Environmental Defense Institute

July 8, 2019 [Rev.2.0]

RE: DRAFT CLASS 3 PERMIT MODIFICATION for the Liquid Waste Management System at the Idaho Nuclear Technology and Engineering Center at the Idaho National Laboratory EPA ID NO. ID4890008952

Abstract

Figure 9: Schematic of filter efficiency with respect to particle size (MMAD is mass median aerodynamic diameter). [pg14]⁵⁴

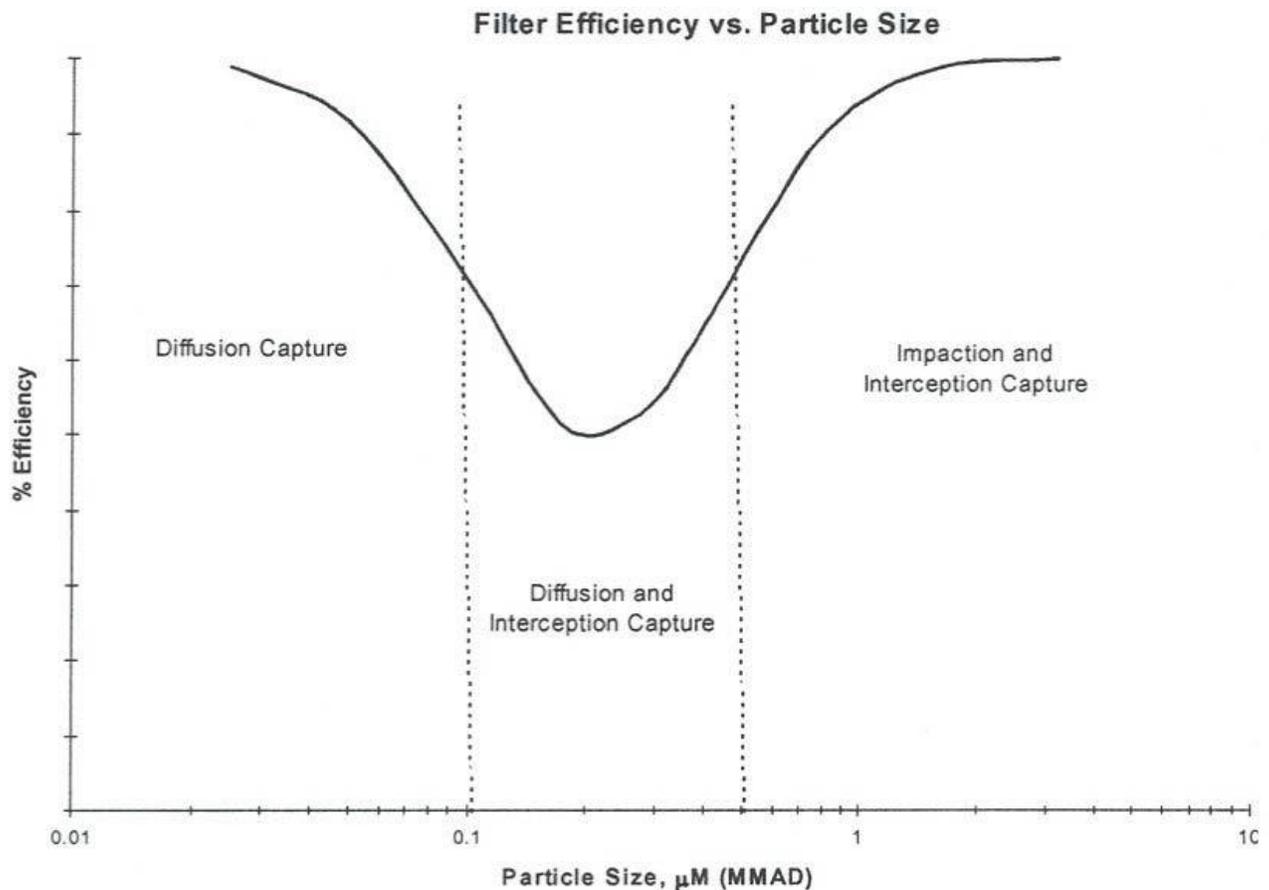
See Figure 9 below that shows how the HEPA filter efficiency drops with smaller particle size.
